IDAP REPORT – SECTION 4.55(1A)

Property:	2 Ismay Avenue HOMEBUSH Lot: 16 DP: 35204 DA2013.193.4
Proposal:	S4.55 (1A) Modification Application for changes to internal layout and approved materials and finishes.
Applicant:	T Wu
Owner:	T Pei
Date of lodgement:	5 April 2022
Notification period:	14 April 2022 to 1 May 2022
Submissions received:	NIL
Assessment officer:	G I Choice
Estimated cost of works:	\$380,000.00
Zoning:	R3-Medium Density Residential - SLEP 2012
Heritage:	No
Flood affected:	Yes
Is a Clause 4.6 Variation Proposed:	No – Clause 4.6 Variation approved under the original consent to enable an amendment to Clause 4.1A of the SLEP 2012 relating to the minimum lot size for dual occupancy developments in R3 Medium Density zones. No changes are sought to the variation of this standard under this modification application.
RECOMMENDATION OF OFFICER:	APPROVAL

Figure 3: Proposed unit 1 floor plans (changes highlighted in yellow)

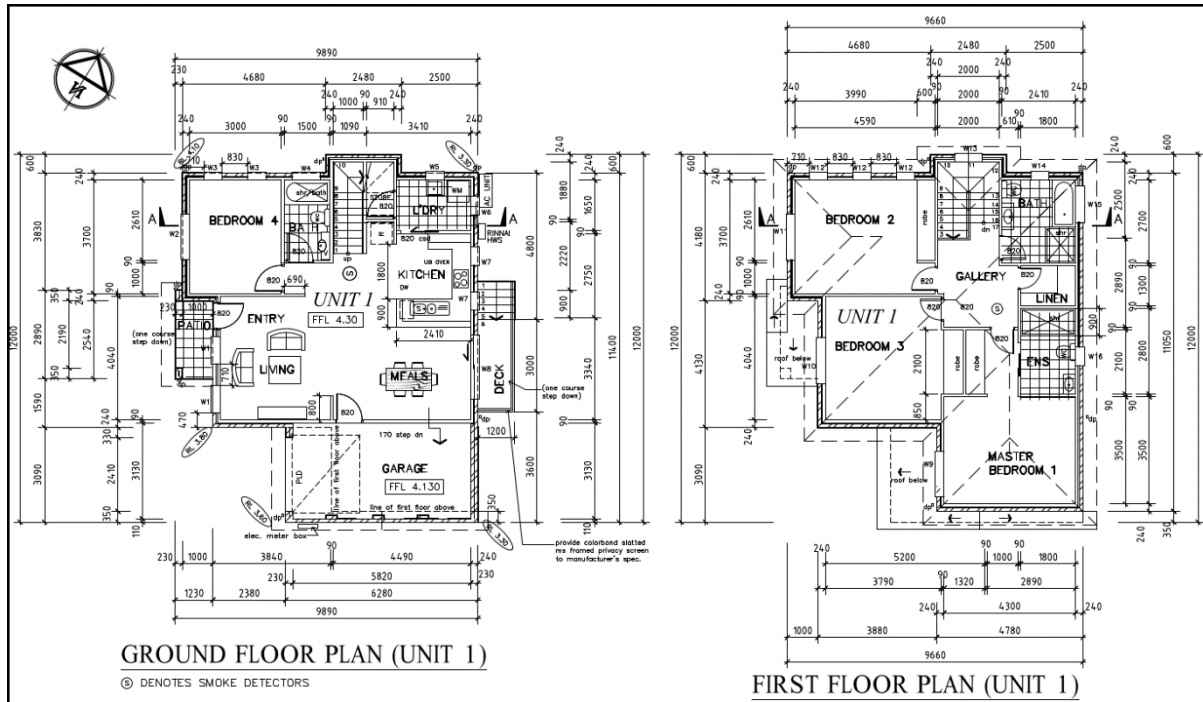
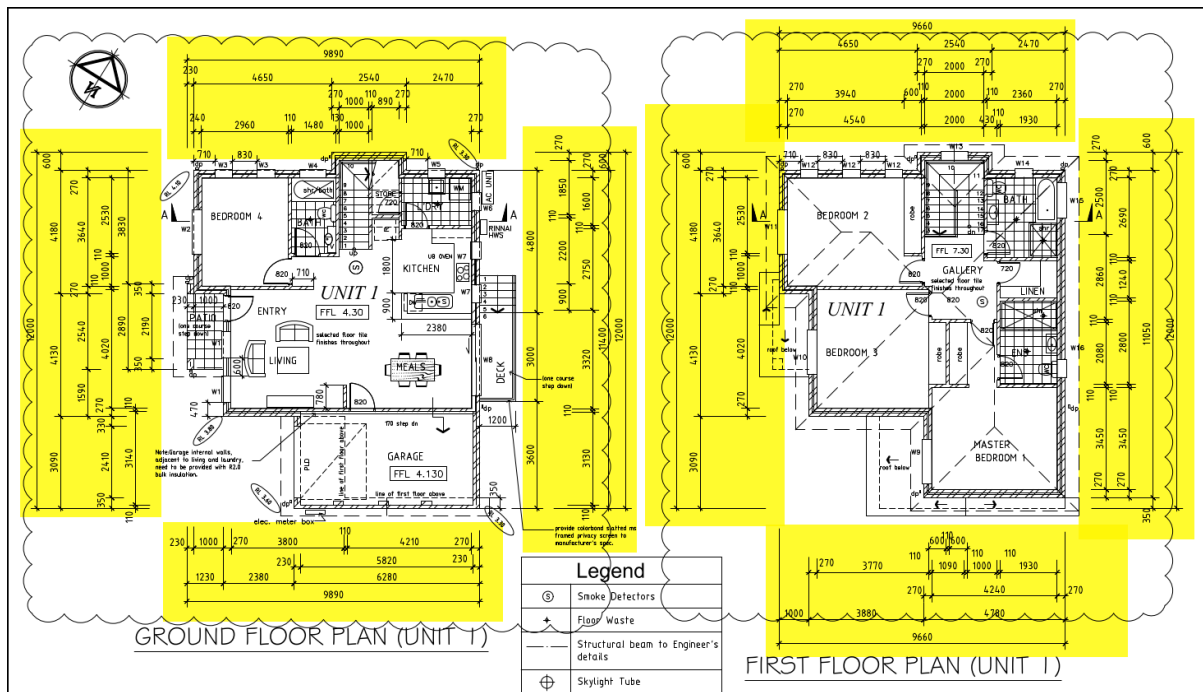
Unit 1

Ground floor level:

- Slight reduction of GFA associated with change to double-brick

First floor level:

- Slight reduction of GFA associated with change to double-brick

External works:

- Brickwork replaced with smooth render (northern/southern/eastern elevations)
- Minor changes to window sizes and locations

Figure 5: Proposed unit 2 floor plans (changes highlighted in yellow)

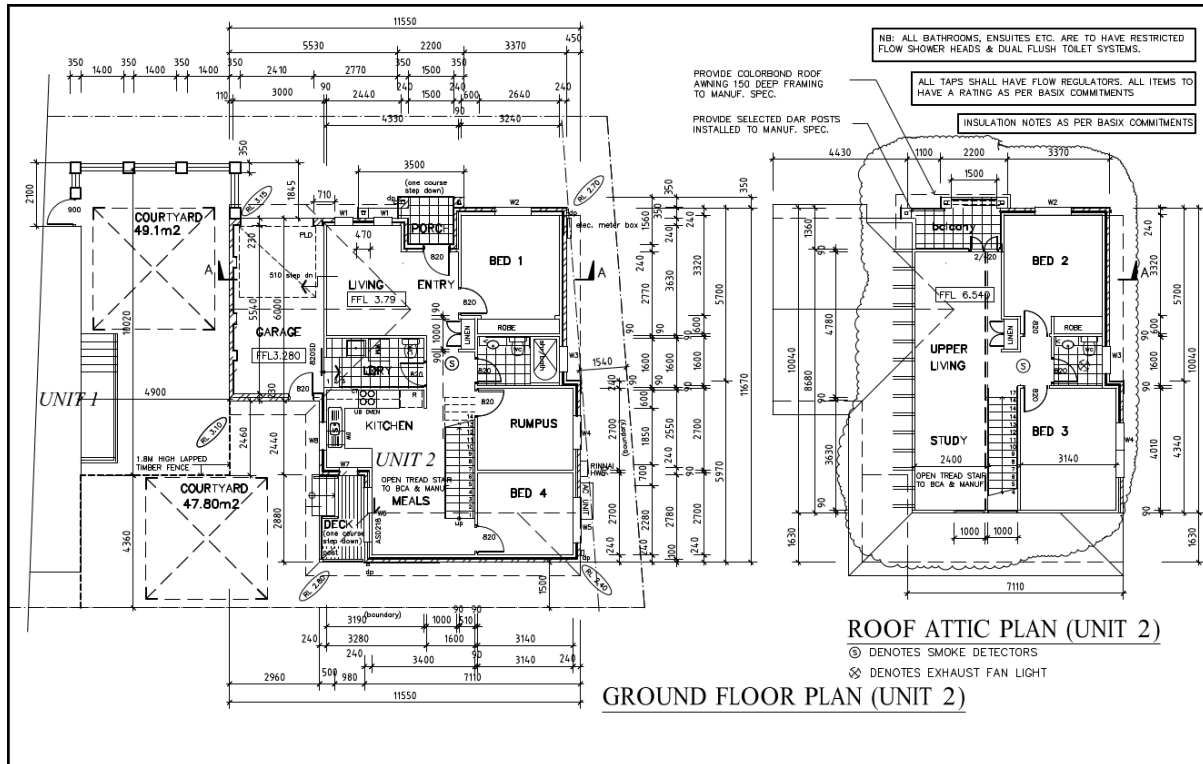
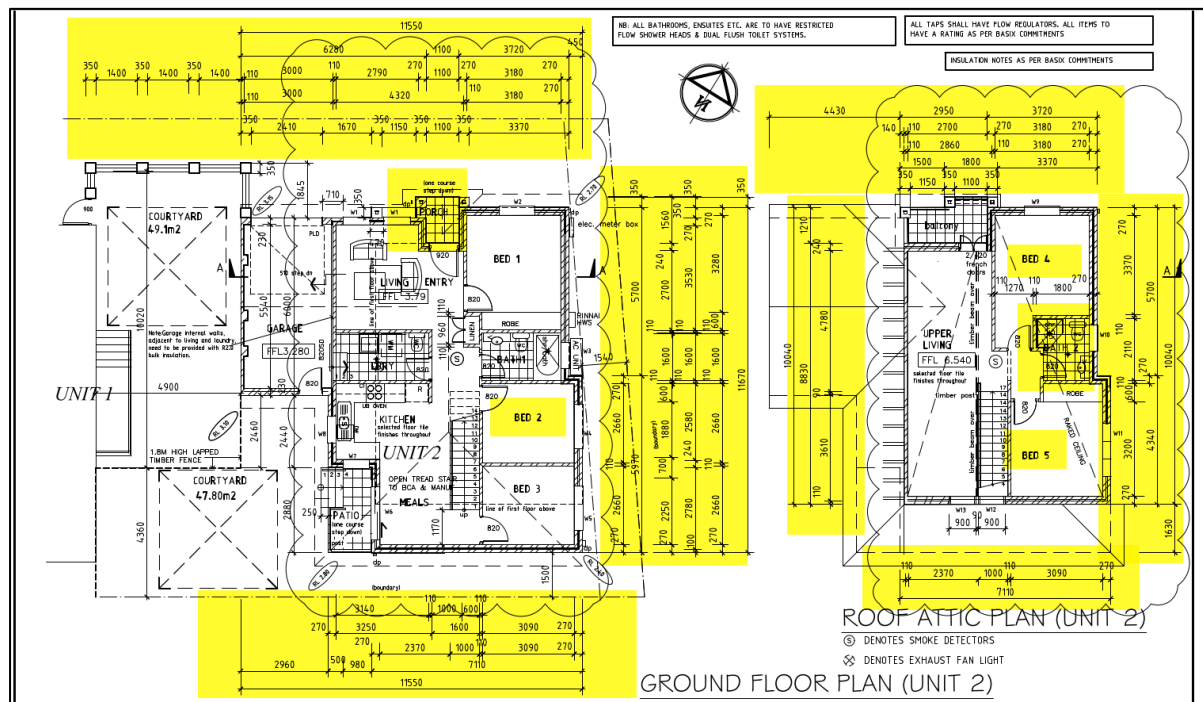
Unit 2

Ground floor level:

- Slight reduction of GFA associated with change to double-brick
- Rumpus room renamed to 'Bed 2' (additional fifth bedroom)
- Reduction of front porch size

First floor level:

- Slight reduction of GFA associated with change to double-brick
- Deletion of bathroom bath

External works:

- Brickwork to replace cladding (northern/southern/eastern/western elevations)
- Minor changes to window sizes and locations

Figure 7: Proposed western & eastern elevations (changes highlighted in yellow/red)

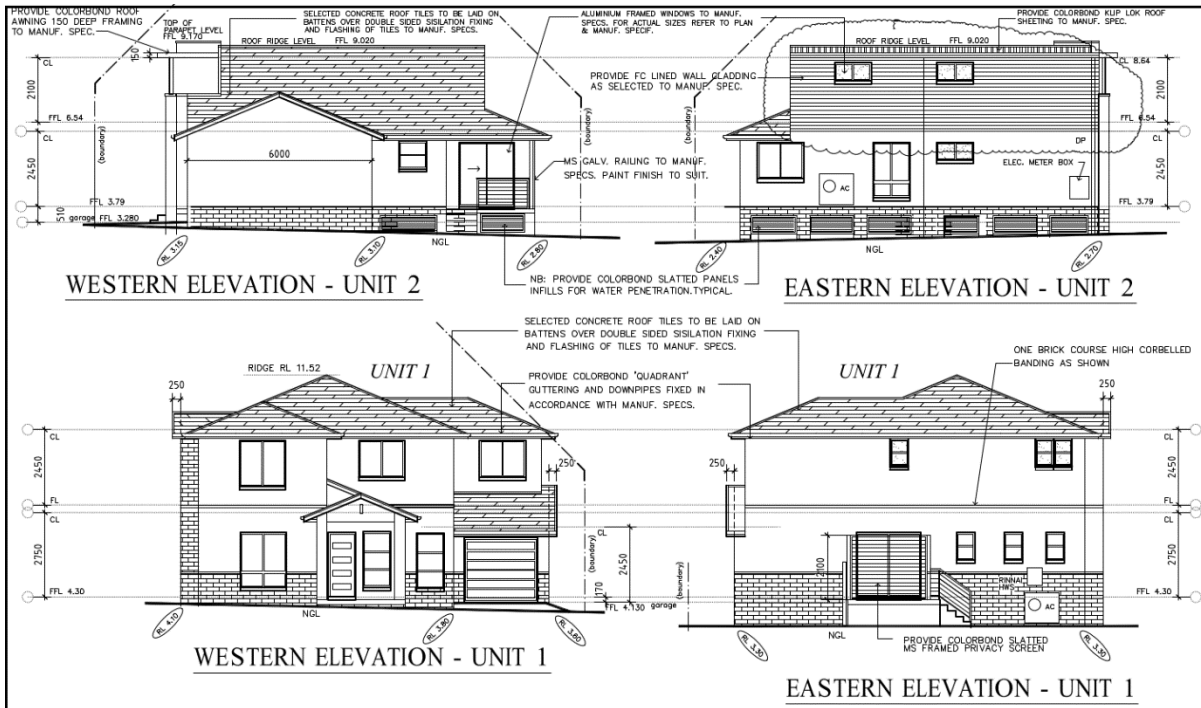
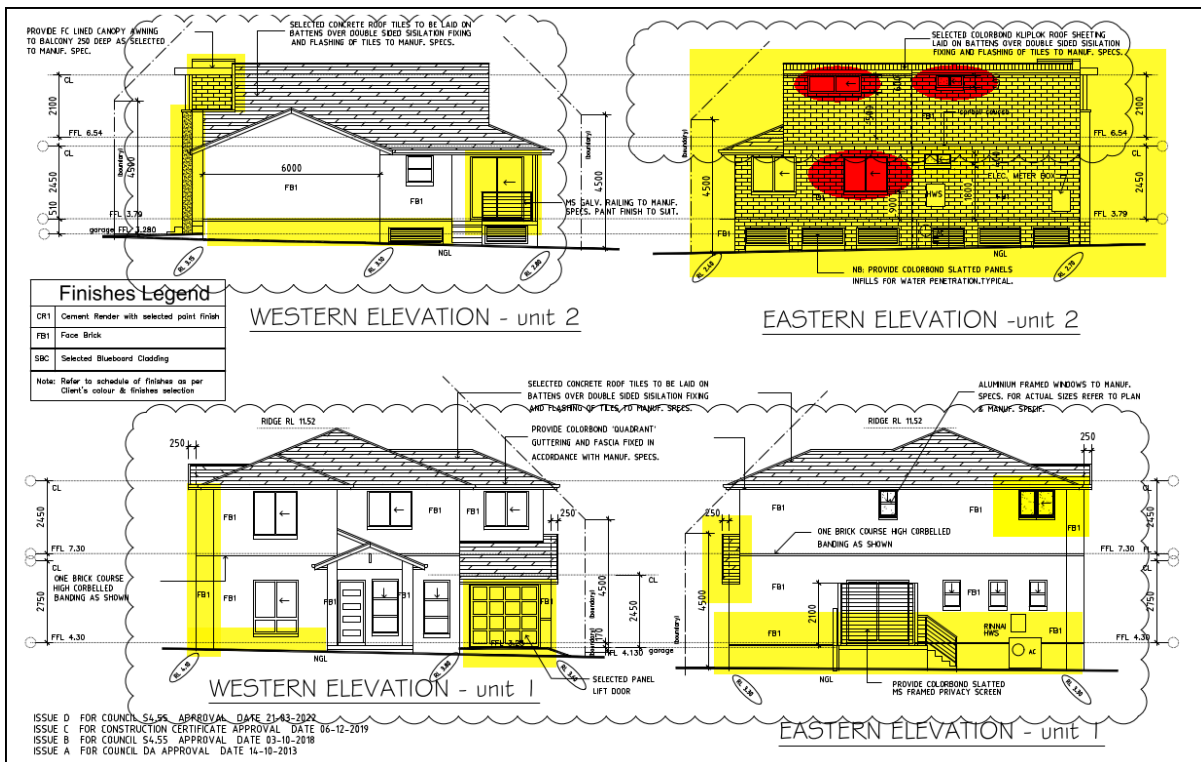
Changes are sought to the external fabric finish, colour schedule or orientation of Unit 1 and 2. These changes comprise the removal of the approved brickwork of the Unit 1 exterior to be replaced with additional smooth render finish; and additional brickwork to the exterior of Unit 2 (see **Figure(s) 6 to 9**). It is considered that the minor changes to the size and position of several windows will not adversely impact privacy of the adjoining resident.
